PG&E Letter DCL-21-062
PG&E Letter DIL-21-007

Diablo Canyon Units 1 and 2
Docket No. 50-275, OL-DPR-80
Docket No. 50-323, OL-DPR-82
Docket No. 72-26, Materials License No. SNM-2511
Diablo Canyon Independent Spent Fuel Storage Installation
License Amendment Request 21-04
Proposed Changes to the Diablo Canyon Power Plant Emergency Plan for Post-Shutdown and Permanently Defueled Condition

Subject: License Amendment Request 21-04, Proposed Changes to the Diablo Canyon Power Plant Emergency Plan for Permanently Shutdown Condition

5.22 FIGURE 5-2, TSC ORGANIZATION

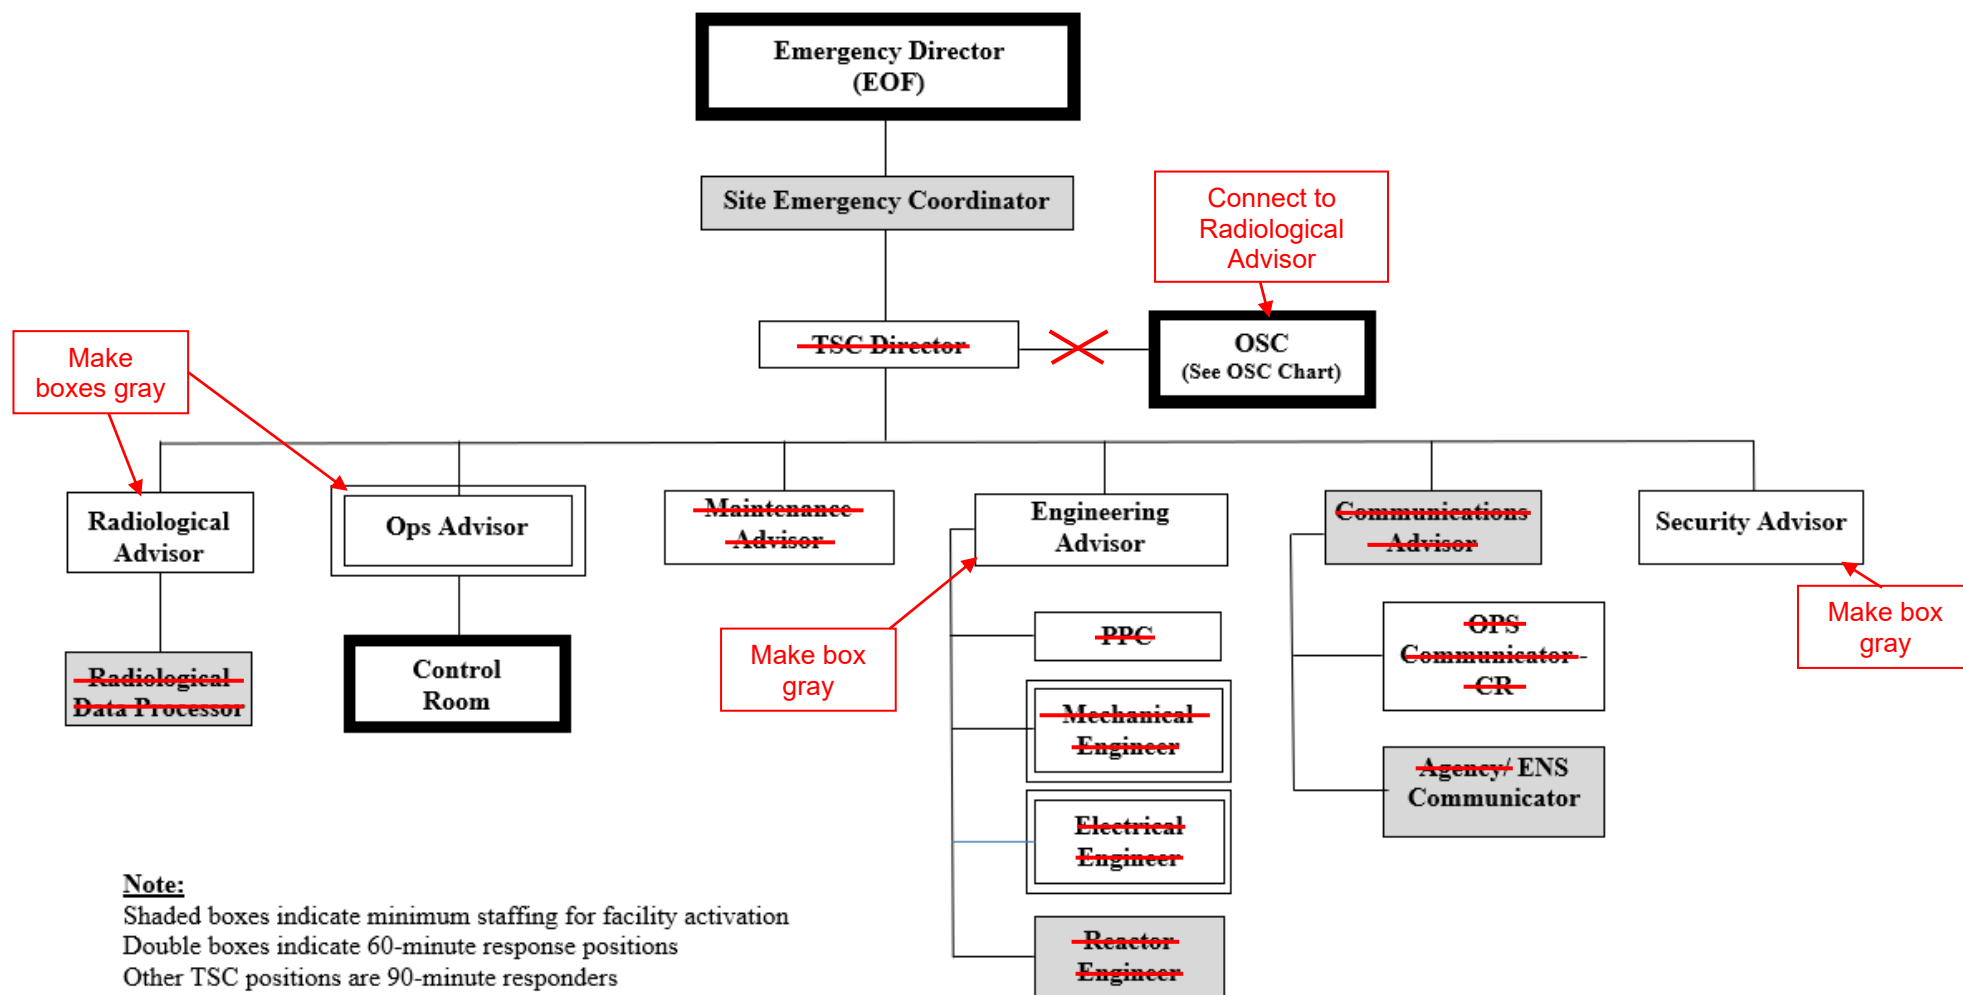
Emergency Plan Section	Current Wording	Proposed Wording	Reason for Change
5.22 Figure 5-2, TSC Organization	Emergency Director (EOF) Site Emergency Coordinator TSC Director Control Room OSC (See OSC Chart) Radiological Advisor Maintenance Advisor Engineering Advisor Ops Advisor Security Advisor Radiological Data Processor PPC Operator Mechanical Engineer Electrical Engineer Reactor Engineer Communications Advisor OPS Communicator – CR Agency/ENS Communicator	Emergency Director (EOF) Site Emergency Coordinator ~~TSC Director~~ Control Room OSC (See OSC Chart) Radiological Advisor ~~Maintenance Advisor~~ Engineering Advisor Ops Advisor Security Advisor ~~Radiological Data Processor~~ ~~PPC Operator~~ ~~Mechanical Engineer~~ ~~Electrical Engineer~~ ~~Reactor Engineer~~ ~~Communications Advisor~~ ~~OPS Communicator – CR~~ ~~Agency/ENS Communicator~~	This revision removes the eliminated positions from the DCP E-Plan. Evaluation of the ERO position responsibilities is performed in Attachment 4 , ERO Task Analysis, including an evaluation of which responsibilities can be deleted and which can be reassigned. See also Section 5.3 for further discussion of ERO positions deleted.

5.23 FIGURE 5-3, OSC ORGANIZATION

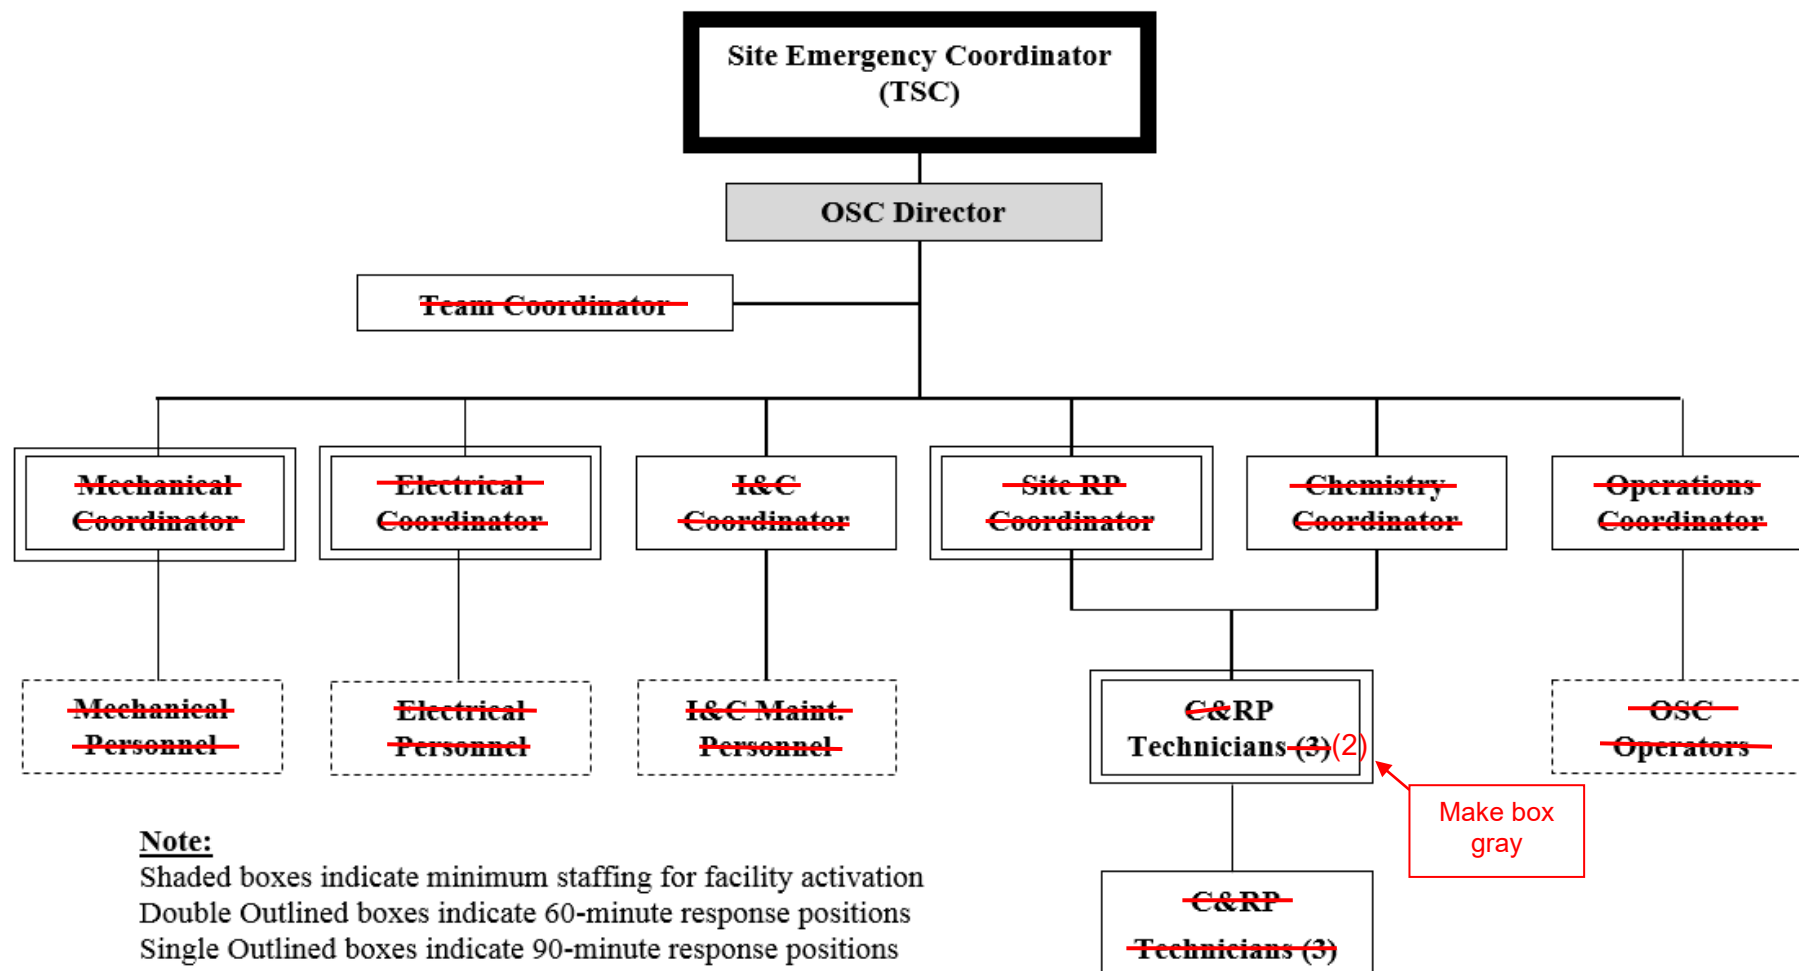
5.23 Figure 5-3, OSC Organization	Site Emergency Coordinator (TSC) OSC Director Team Coordinator Mechanical Coordinator Electrical Coordinator I&C Coordinator Site RP Coordinator Chemistry Coordinator Operations Coordinator Mechanical Personnel Electrical Personnel I&C Maint Personnel C&RP Technicians (3) OSC Operators C&RP Technicians (3)	Site Emergency Coordinator (TSC) OSC Director ~~Team Coordinator~~ ~~Mechanical Coordinator~~ ~~Electrical Coordinator~~ ~~I&C Coordinator~~ ~~Site RP Coordinator~~ ~~Chemistry Coordinator~~ ~~Operations Coordinator~~ ~~Mechanical Personnel~~ ~~Electrical Personnel~~ ~~I&C Maint Personnel~~ ~~C&RP Technicians (32)~~ ~~OSC Operators~~ ~~C&RP Technicians (3)~~	This revision removes the eliminated positions from the DCP E-Plan. Evaluation of the ERO position responsibilities is performed in Attachment 4 , ERO Task Analysis, including an evaluation of which responsibilities can be deleted and which can be reassigned. See also Section 5.3 for further discussion of ERO positions deleted.

Shaded boxes indicate minimum staffing for facility activation
Double Outlined boxes indicate 60-minute response positions
Single Outlined boxes indicate 90-minute response positions
Dotted Outlined boxes indicate called in positions
~~On Site FMT initially reports to OSC Site Radiation Protection Coordinator (see Figure 5-4)~~

5.24 FIGURE 5-4, EOF ORGANIZATION

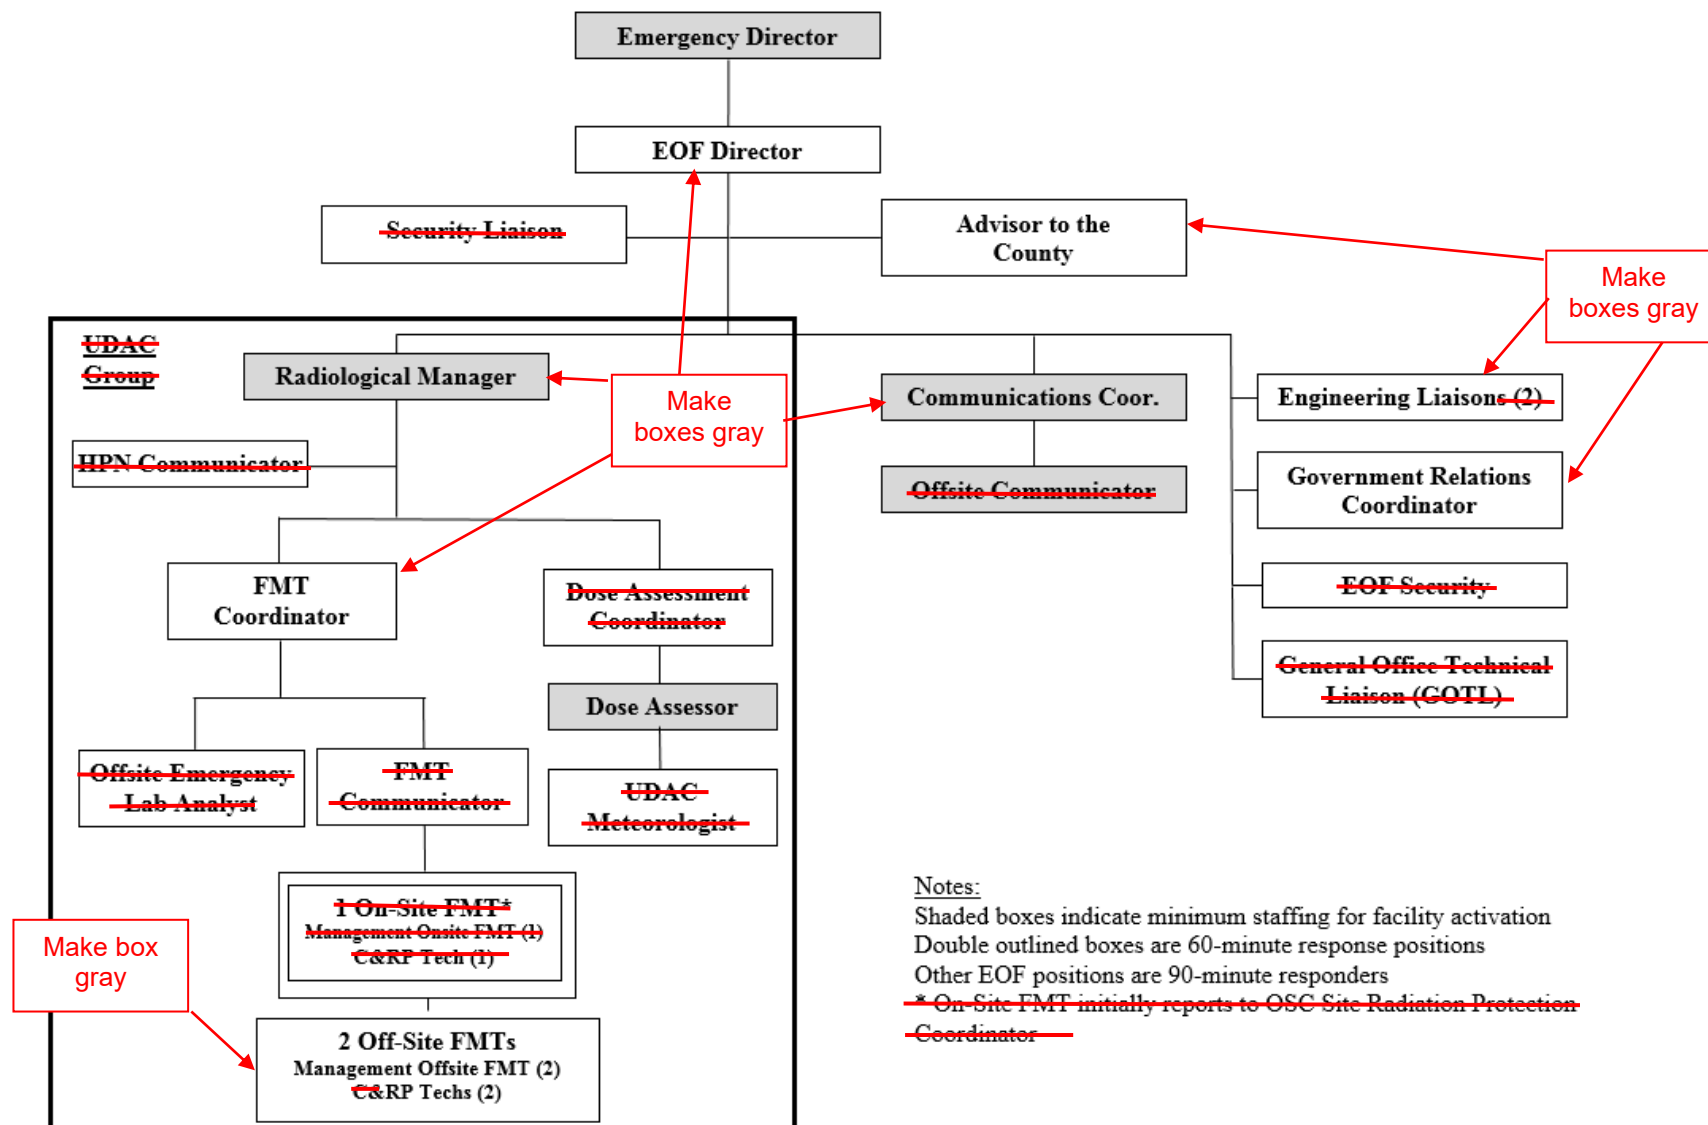
5.24 Figure 5-4, EOF Organization	Emergency Director EOF Director Security Liaison Advisor to the County UDAC Radiological Manager HPN Communicator FMT Coordinator Dose Assessment Coordinator Dose Assessor Offsite Emergency Lab Analyst FMT Communicator 1 On-Site FMT* Management Onsite FMT (1)	Emergency Director EOF Director ~~Security Liaison~~ Advisor to the County ~~UDAC~~ Radiological Manager ~~HPN Communicator~~ FMT Coordinator ~~Dose Assessment Coordinator~~ Dose Assessor ~~Offsite Emergency Lab Analyst~~ ~~FMT Communicator~~ ~~1 On-Site FMT*~~ ~~Management Onsite FMT (1)~~	This revision removes the eliminated positions from the DCP E-Plan. Evaluation of the ERO position responsibilities is performed in Attachment 4 , ERO Task Analysis, including an evaluation of which responsibilities can be deleted and which can be reassigned. See also Section 5.3 for further discussion of ERO positions deleted.

5.25 FIGURE 5-5, JIC ORGANIZATION

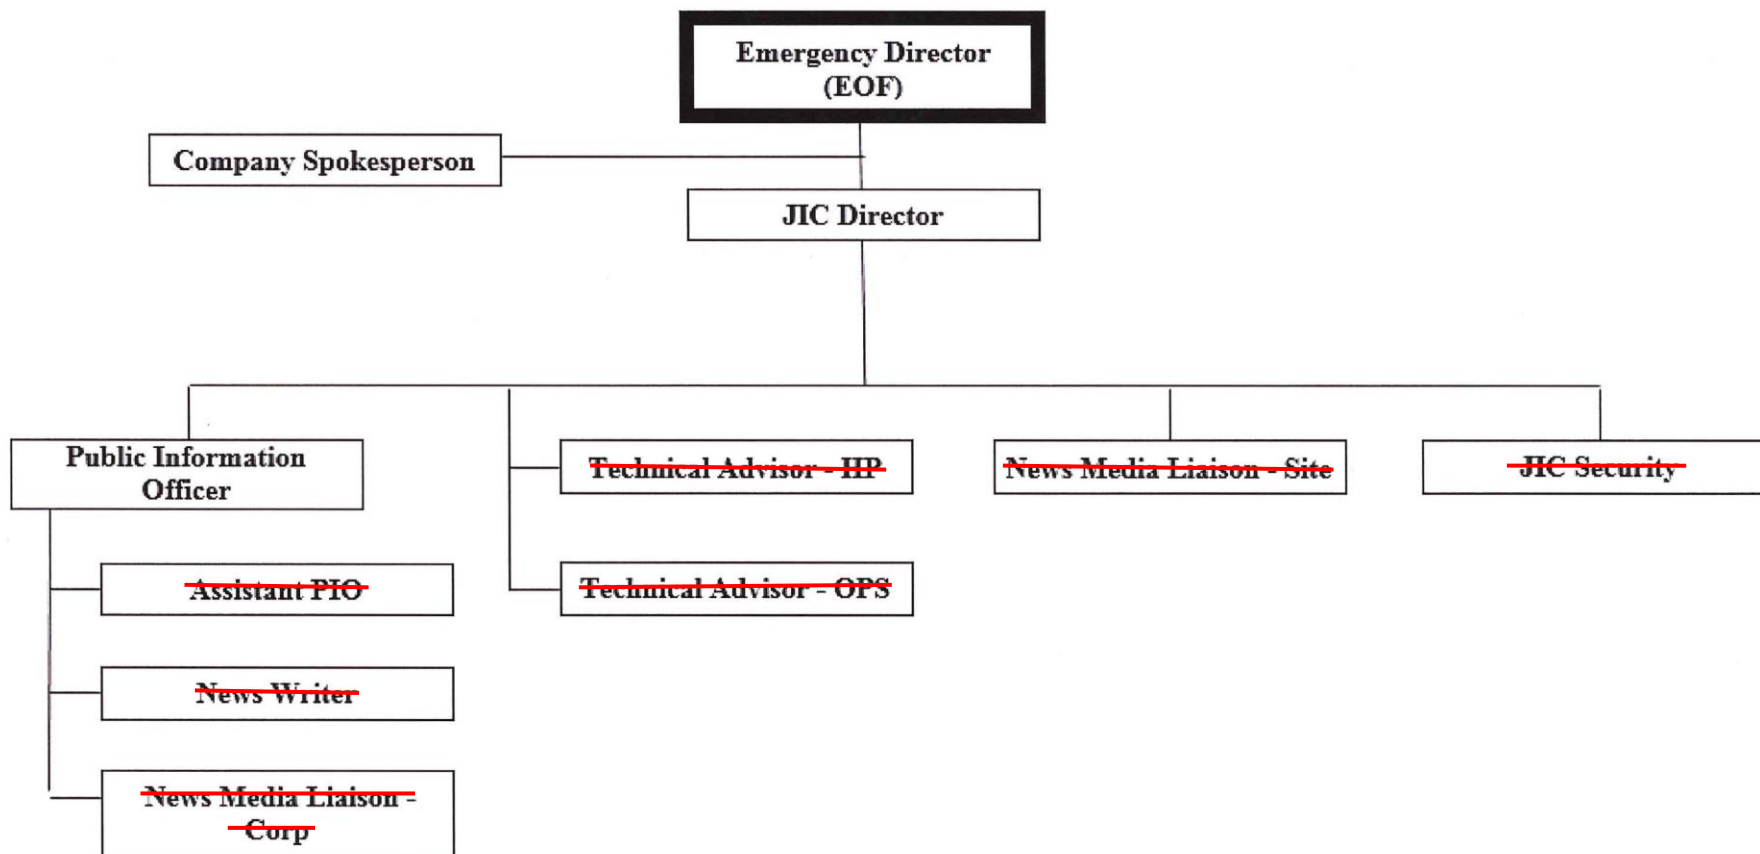
5.25 Figure 5-5, JIC Organization	Emergency Director (EOF) Company Spokesperson JIC Director Public Information Officer Assistant PIO News Writer News Media Liaison – Corp. Technical Advisor – HP Technical Advisor – OPS News Media Liaison – Site JIC Security	Emergency Director (EOF) Company Spokesperson JIC Director Public Information Officer ~~Assistant PIO~~ ~~News Writer~~ ~~News Media Liaison – Corp.~~ ~~Technical Advisor – HP~~ ~~Technical Advisor – OPS~~ ~~News Media Liaison – Site~~ ~~JIC Security~~	This revision removes the eliminated positions from the DCPPE-Plan. Evaluation of the ERO position responsibilities is performed in Attachment 4 , ERO Task Analysis, including an evaluation of which responsibilities can be deleted and which can be reassigned. See also Section 5.3 for further discussion of ERO positions deleted.

7.1.3.1 — Location

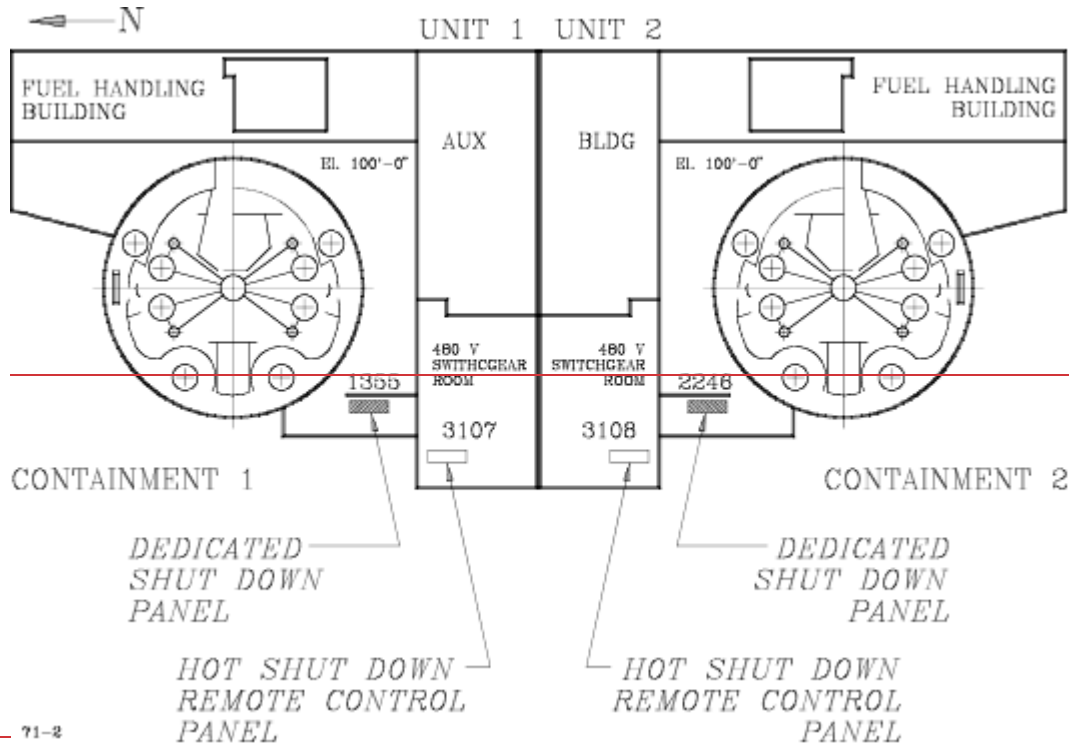
~~Each unit is provided with a dedicated shutdown panel located in the 100' elevation of the Auxiliary Building, as shown below.~~
